MONTICELLO NUCLEAR GENERATING PLANT

AMENDMENT TO FACILITY OPERATING LICENSE

Amendment No. 3
License No. DPR-22

ATTACHMENT TO LICENSE AMENDMENT NO.

FIGURE 6.1.2

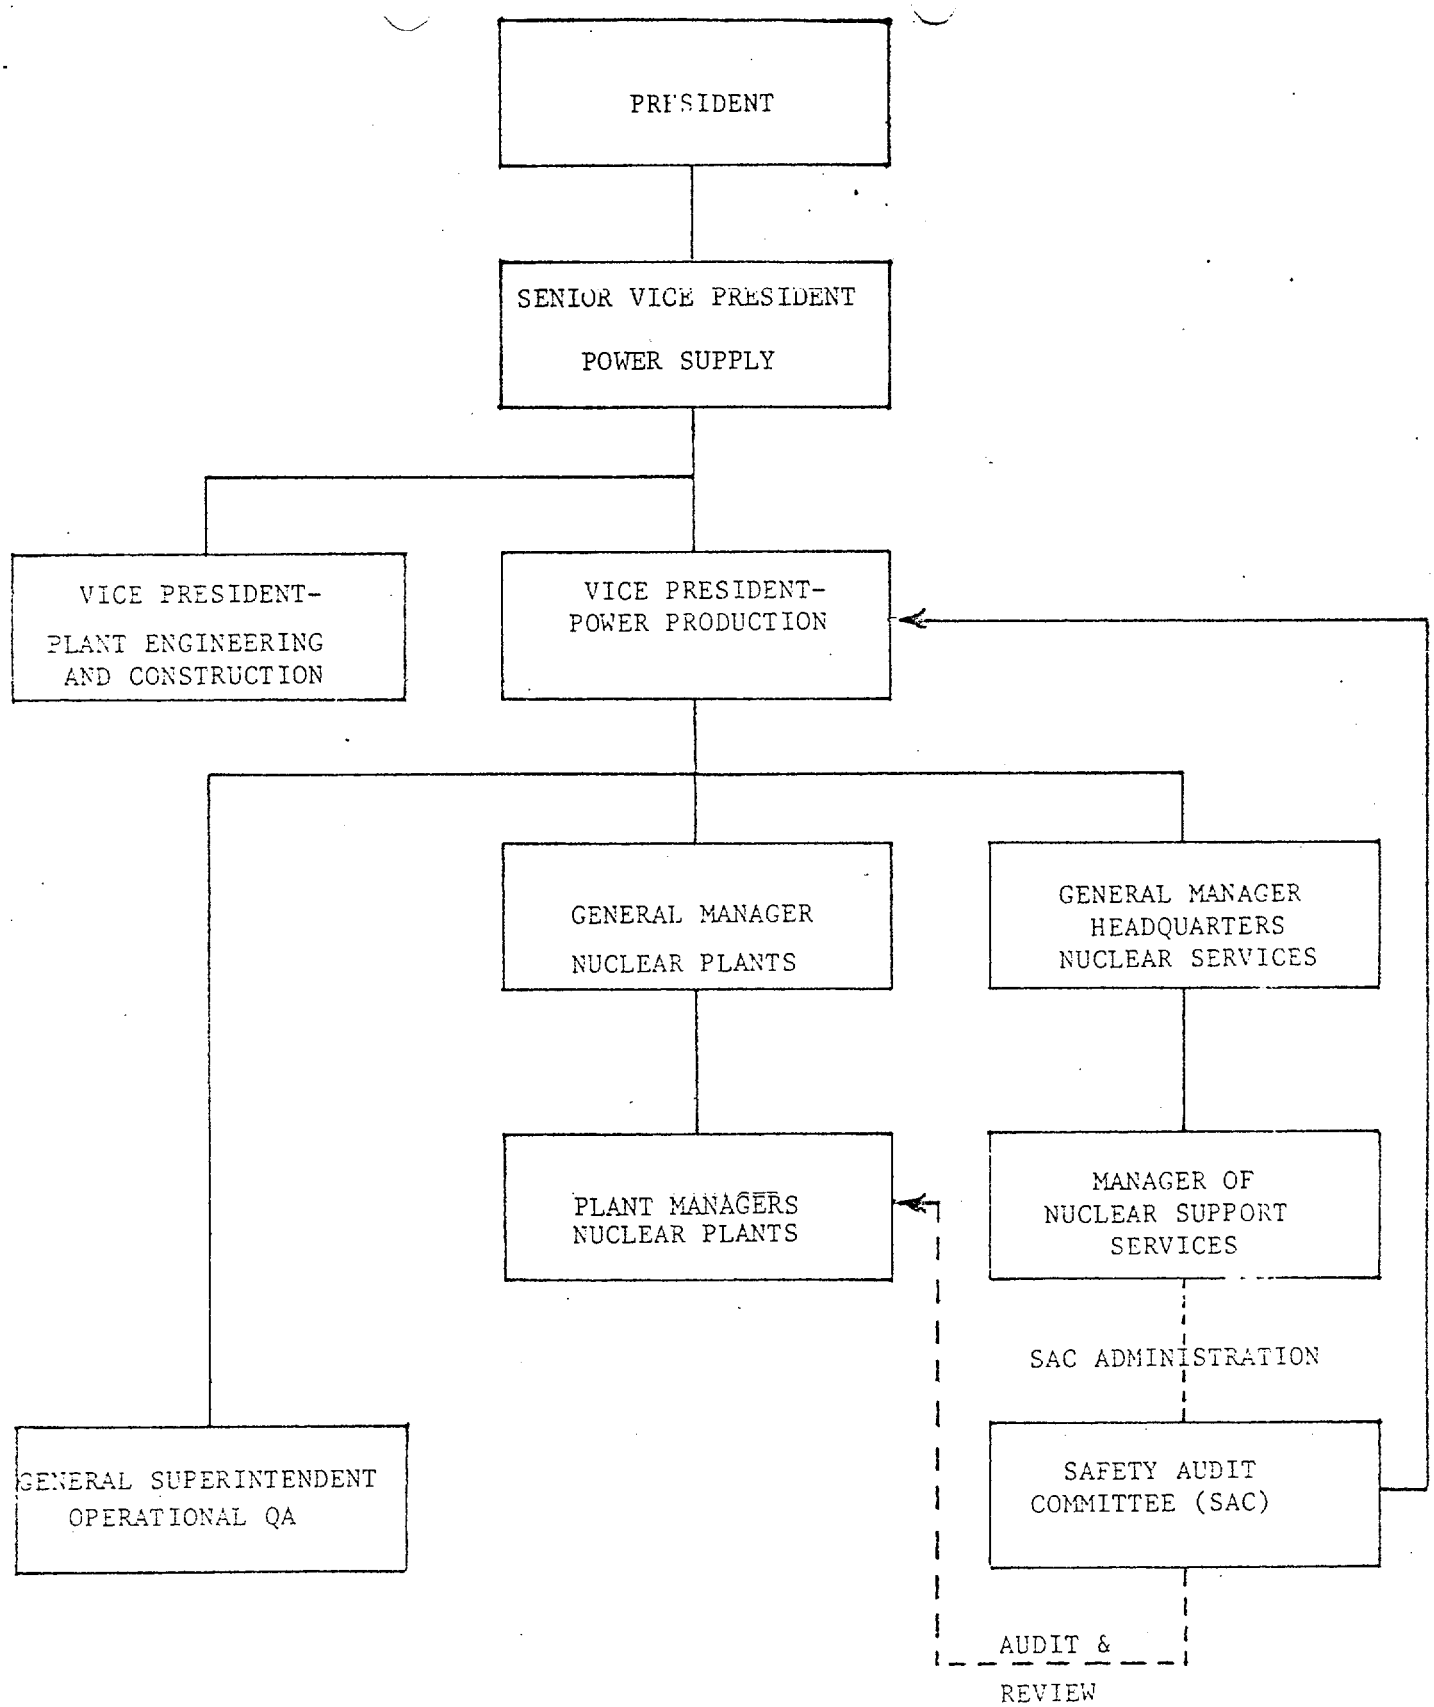
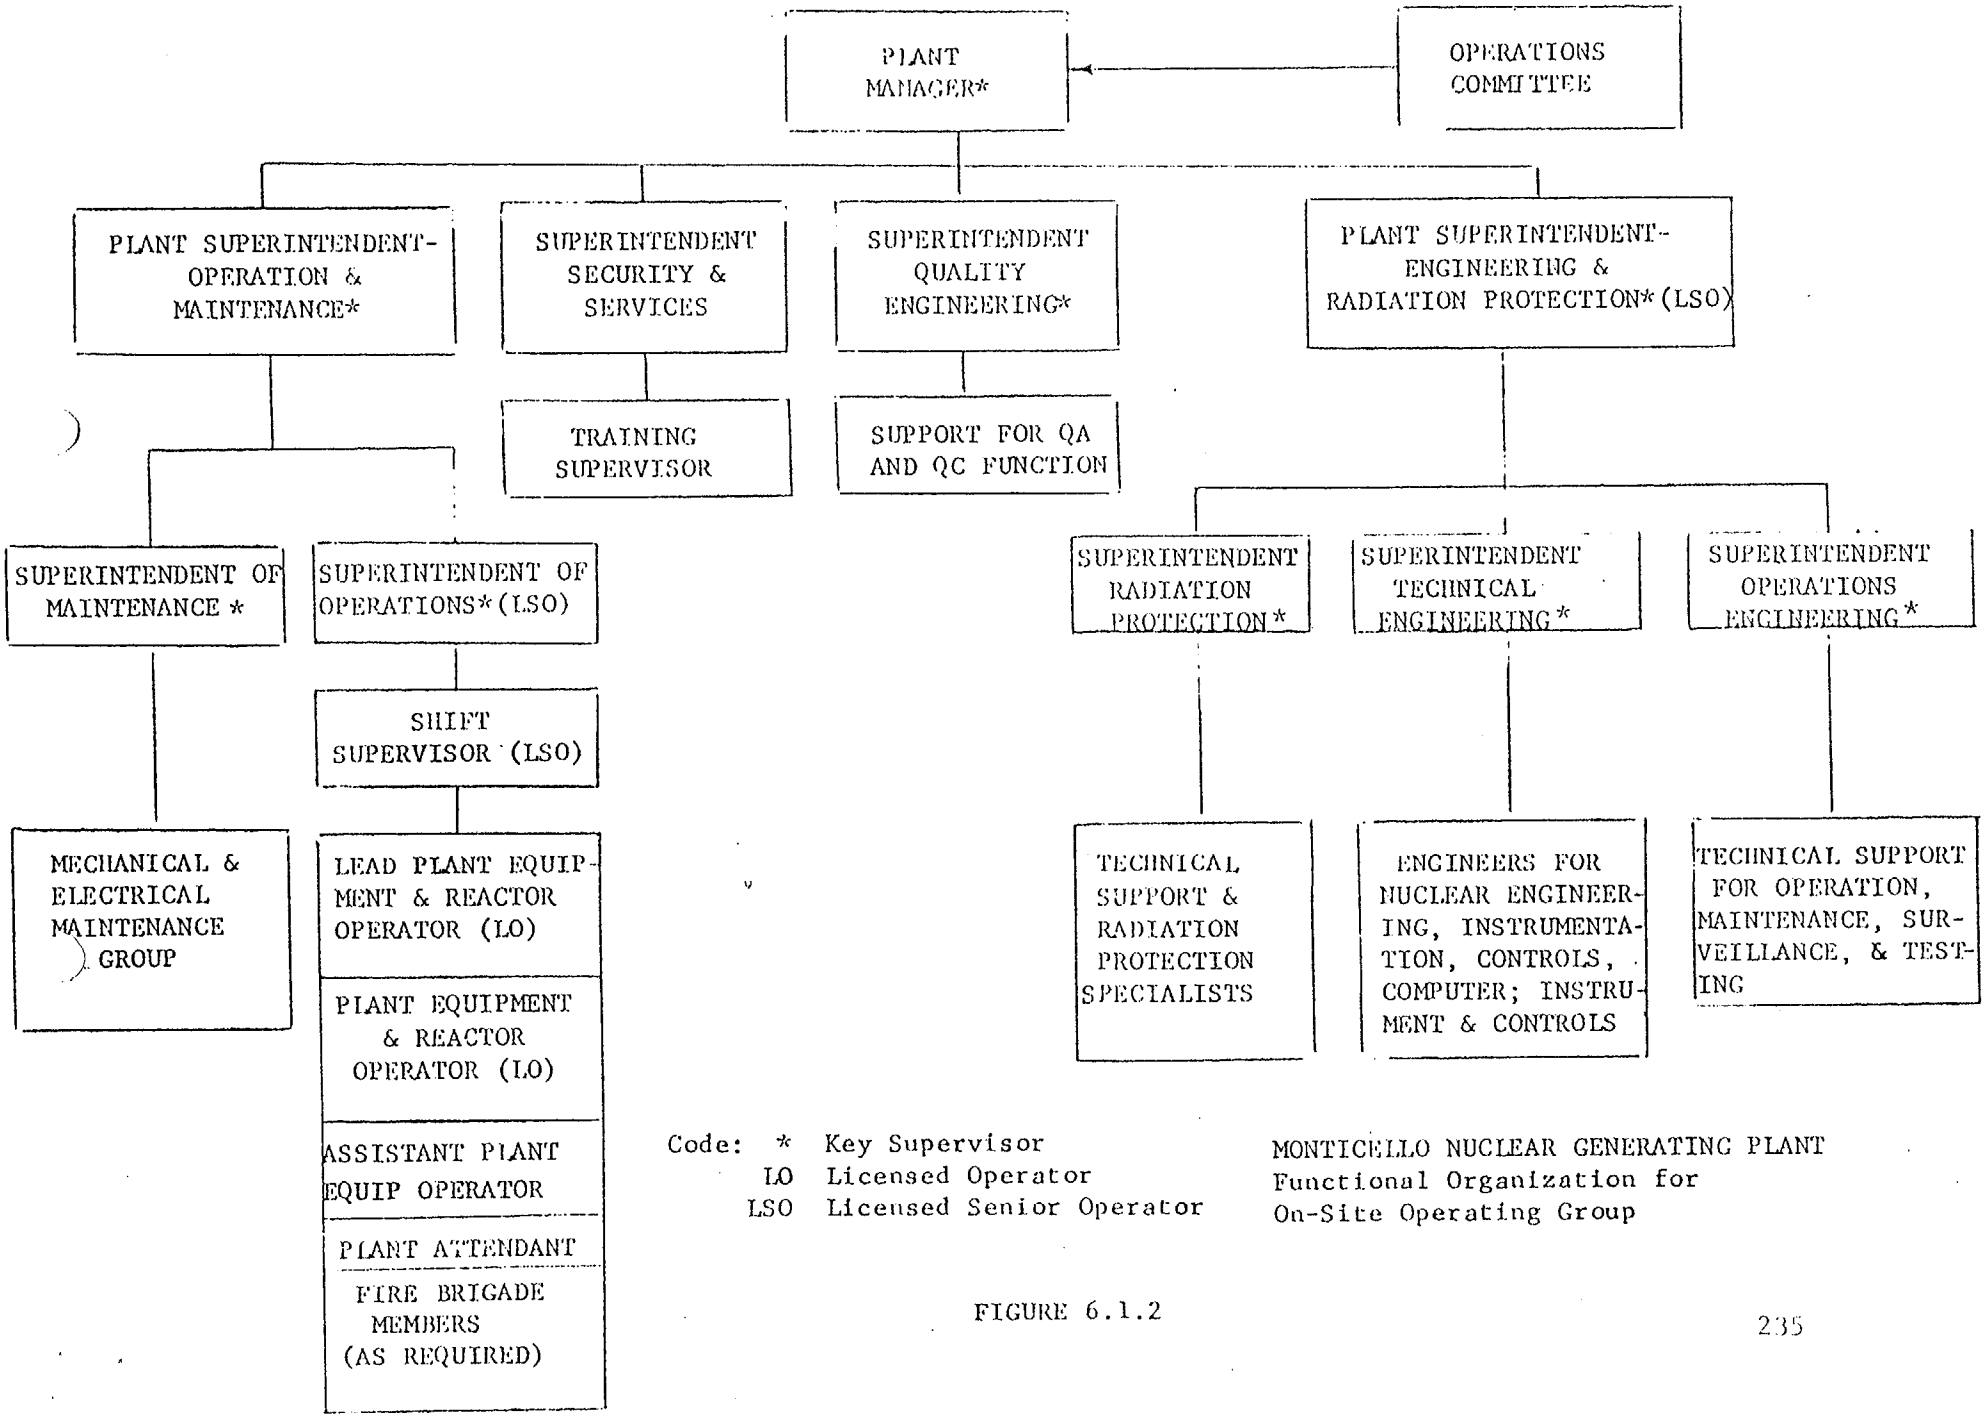
We have determined that these changes incorporate a change in corporate organization involving electric generating plant responsibilities and a change in Power Production Department organization to provide greater participation in, and technical support for, nuclear plant activities. These changes are administrative in nature and are acceptable.
